工程指示 / 要求簡箋(E.I.)

工程指示編號：EI / 1497 / 20

工程名稱：觀塘裕民坊

工程項目：特式層 窗門 access panel 拆圖資料 (Delete T2W SA-02)

TOWER 2 (ST-2) ROOF FLOOR

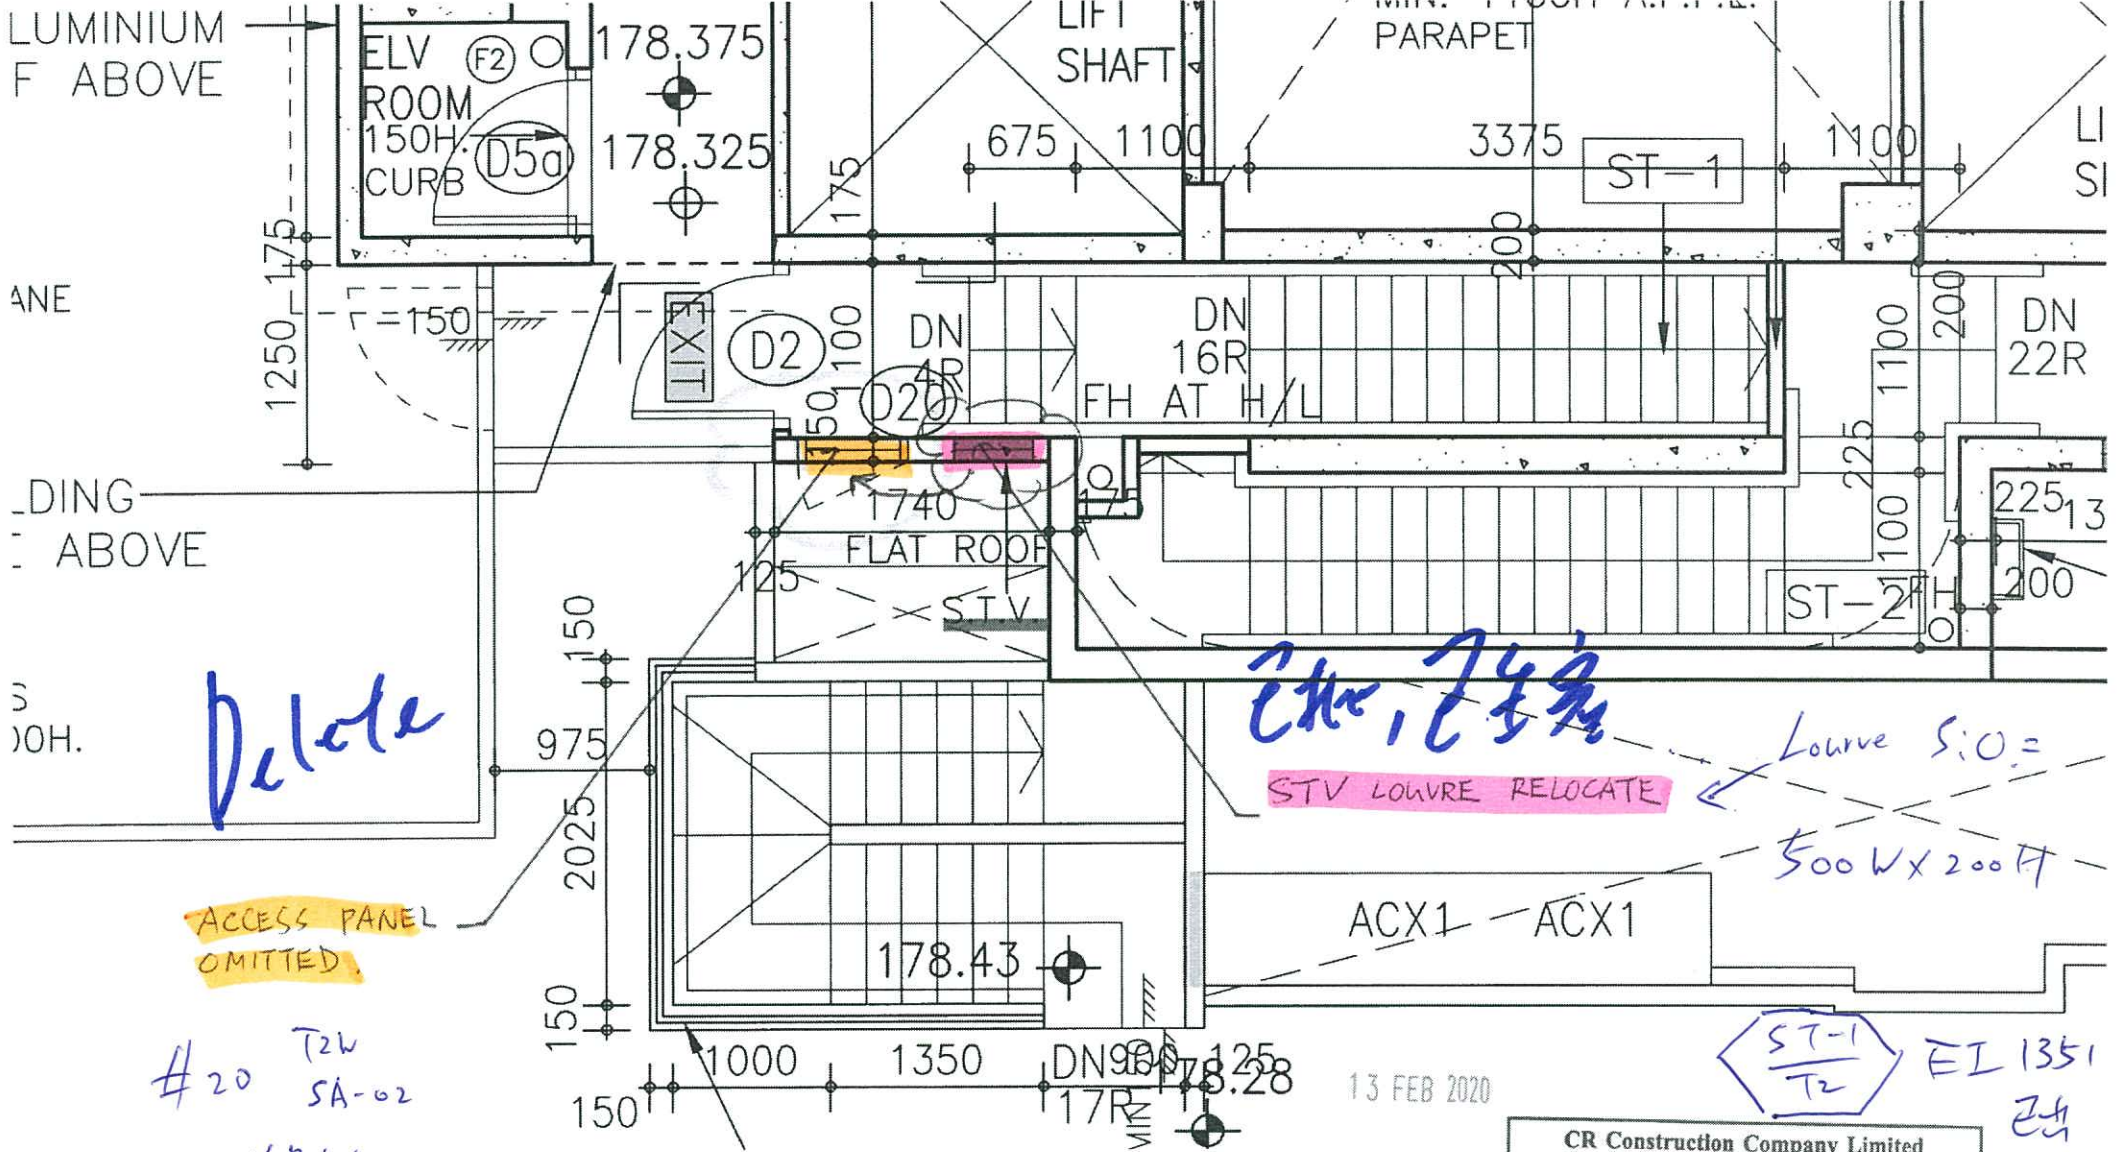
ACCESS PANEL OMITTED

#20 T2W SA-02

X Delete access panel.

STV LOWVRE RELOCATE

Lowvre S/O = 500 W x 200 H

TOWER 2
(ST-2)

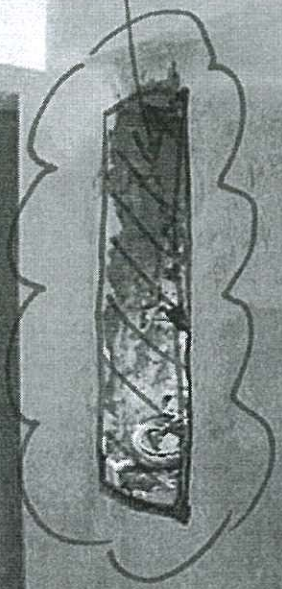
OMITTED
(COVER UP)

S.T.V LOWVRE (BY MIDI)
500(W)x 200(H)

ACCESS PANEL
OMITTED
(COVER UP
R.C. WALL)
